Arafura Resources Ltd
Nolans Project
Section 14A Notification

June 2019

Arafura is proposing changes to the assessed Nolans Project, and submits this document as notification of the proposed alterations, in accordance with Clause 14A of the Environmental Assessment Administrative Procedures.

Figure 3-1 Mine site revised general arrangement

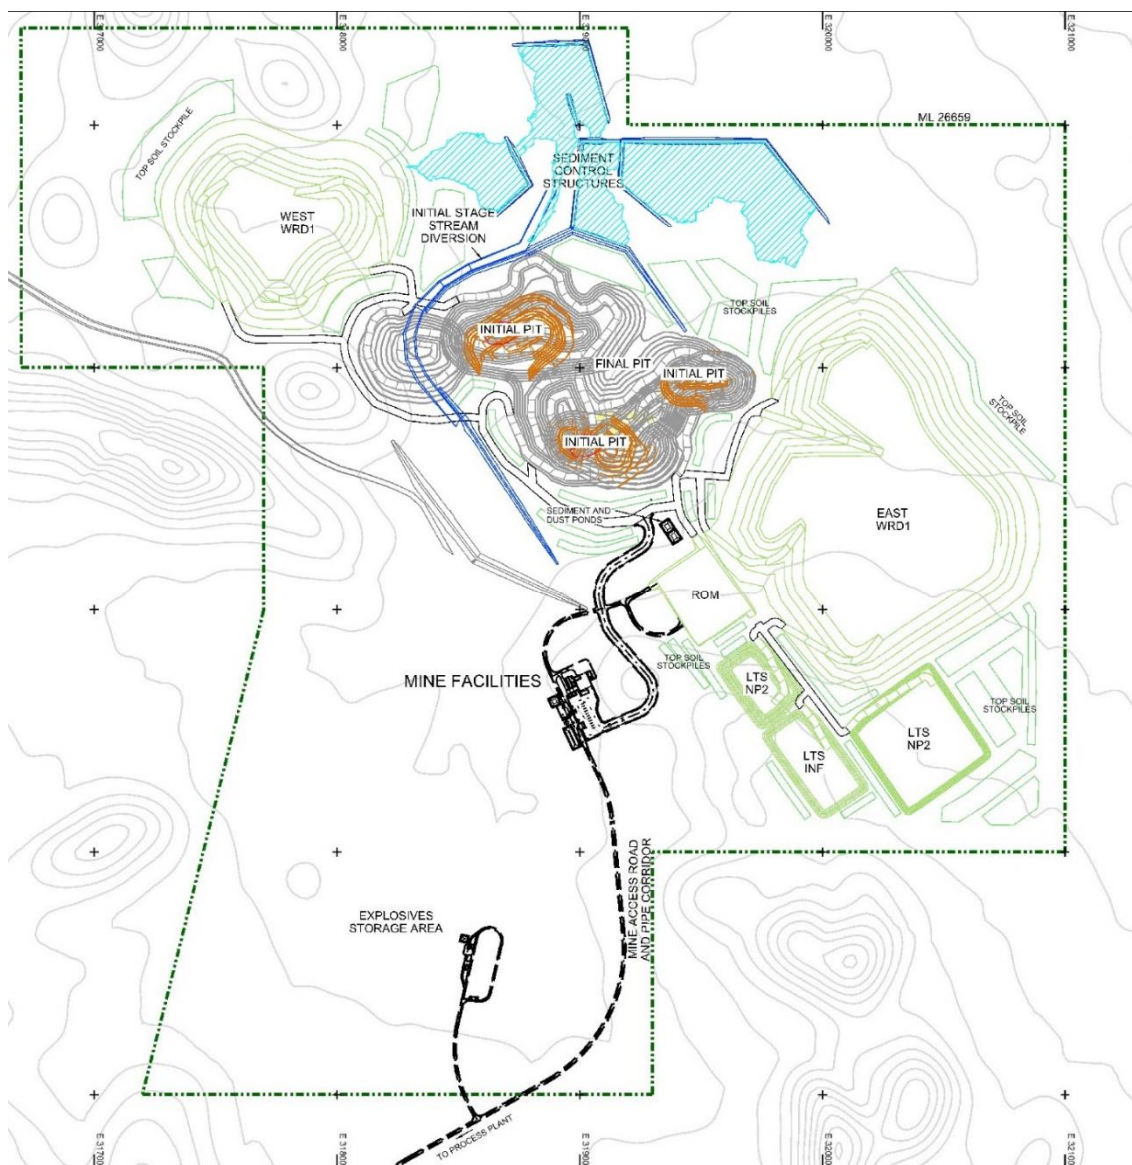
The Revised mine site general arrangement is contained in in Figure 3-1 and Appendix A, Drawing 801-140-A5001-050. Key changes include the removal of tailings storage facility from the mine site and relocation to the processing site as part of a combined tailings and residue storage facility.

Mining operations will be 24 hours/day. Overburden and waste rock will be deposited in 2 purpose-constructed WRDs over the LOM (Figure 3-1). This is a reduction from the 6 WRDs proposed in the Assessed Project.

Low grade ore will be stockpiled in a long term stockpile at the mine site. The long term stockpile will store lower grade and non-PAPL preferred ore for future processing (see Figure 3-1). The revised Project has the long-term stockpile (LTS) located adjacent to WRD1 East which will enable simple future rehabilitation of this ore, if a decision is made to not process this ore. The LTS will be built on a compacted layer of material and rehabilitation would involve covering the ore with a 2m capping of benign waste rock to minimise erosion and provide shielding as with the waste rock dumps.

Typical terrain Reynolds Range

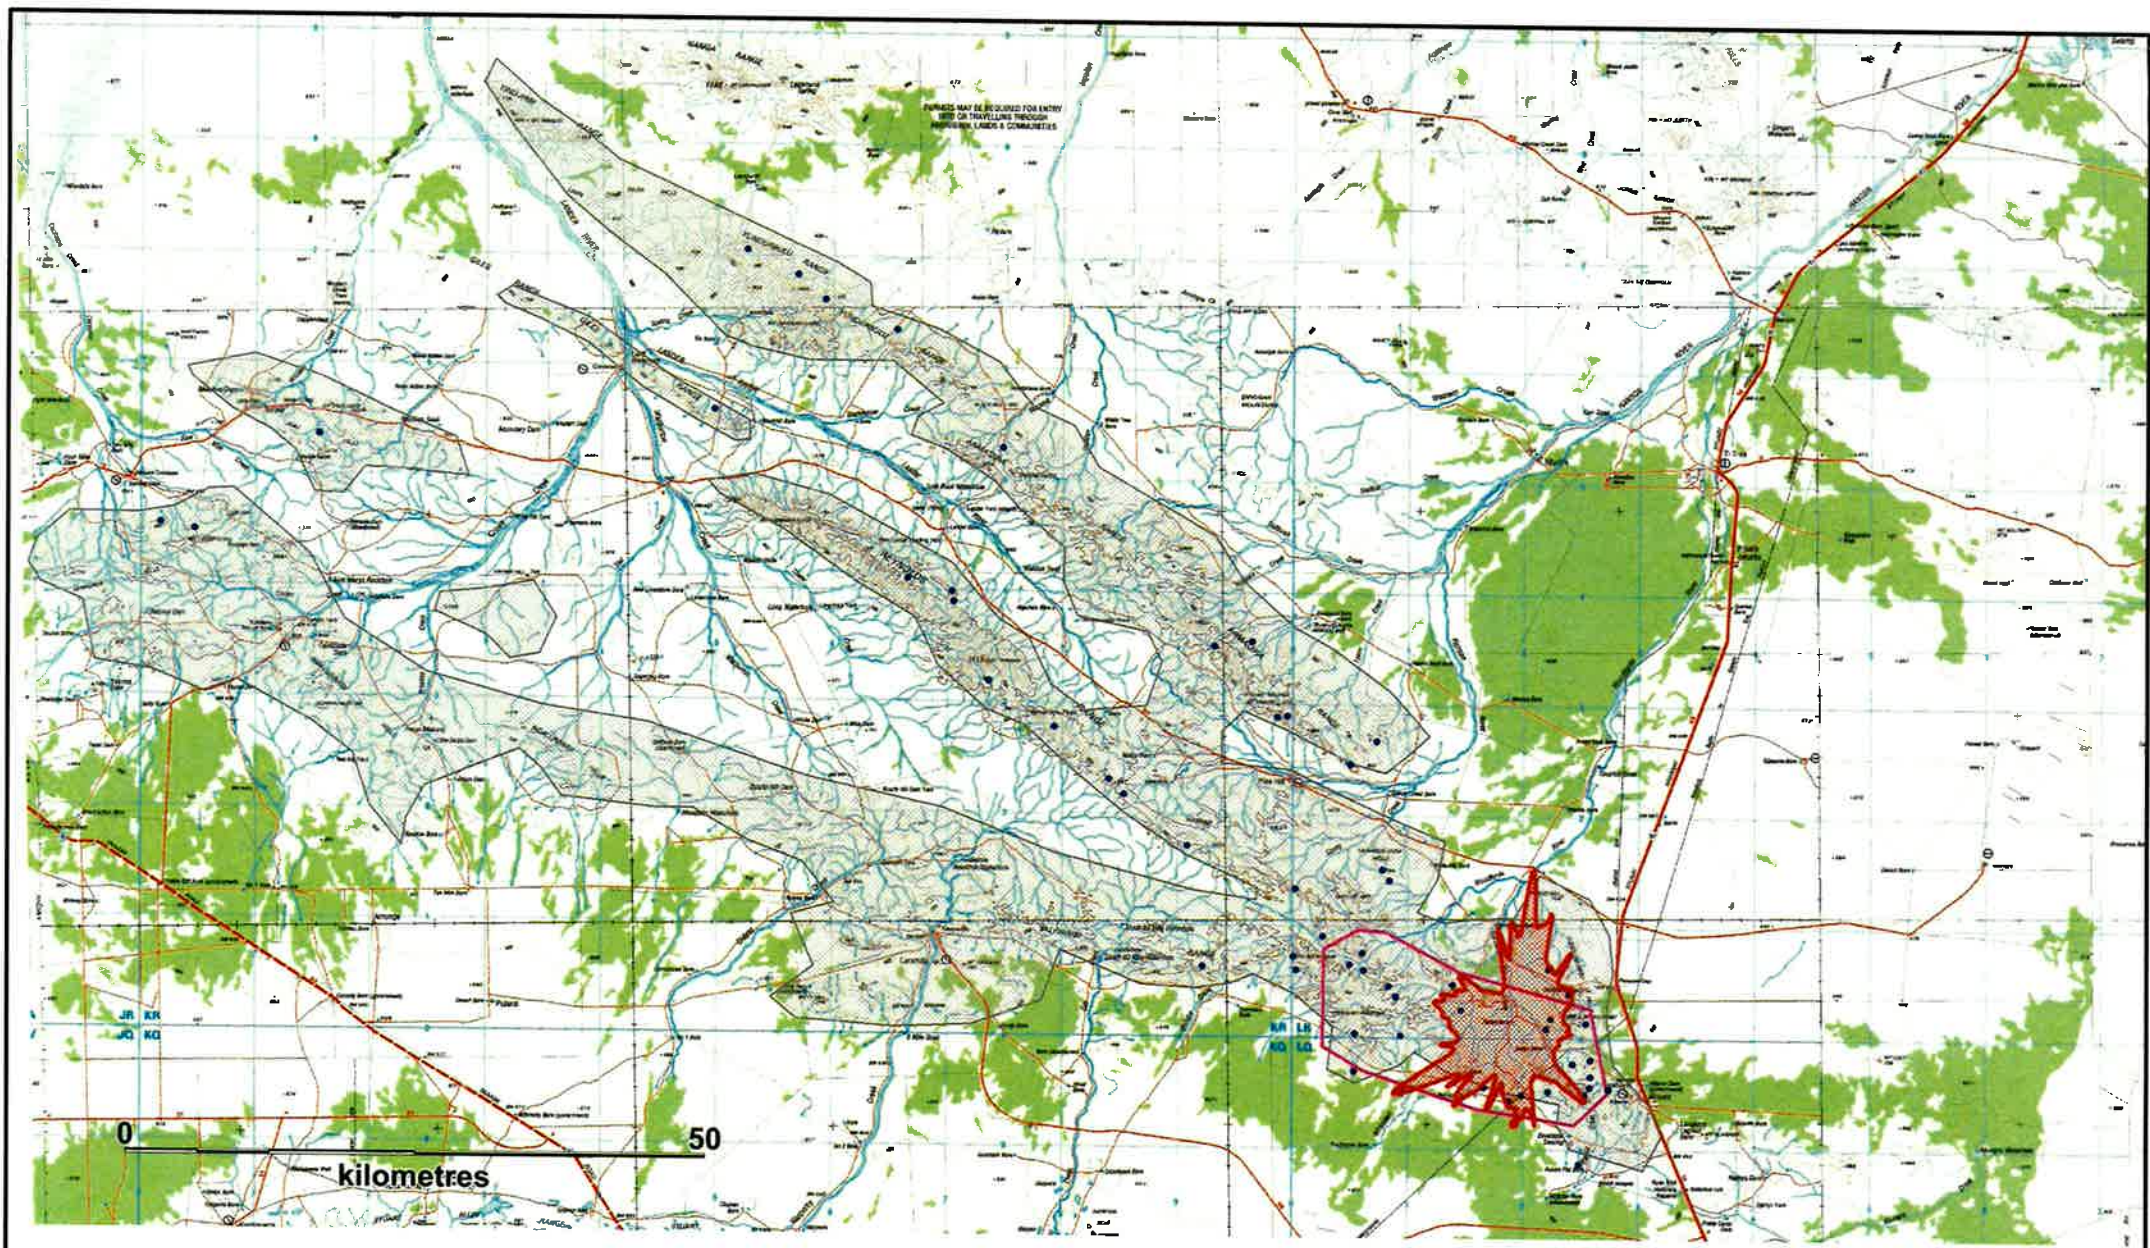
- DENR's assertion that inadequate survey effort was applied is refuted. The terrain encountered and present in the study area and regionally, exceeds over 3000sq kms is rugged and inaccessible other than on foot. The study area assessed represented a significant portion of this potential habitat. Because of the nature of the terrain and generally the poor accessibility, Arafura used a helicopter to fly the 3 study teams to the 65 selected study locations near the project area to conduct the survey assessments, at a significant cost. There were no responses from DENR on the adequacy of the surveys completed in either the Draft EIS or the Supplementary EIS document.
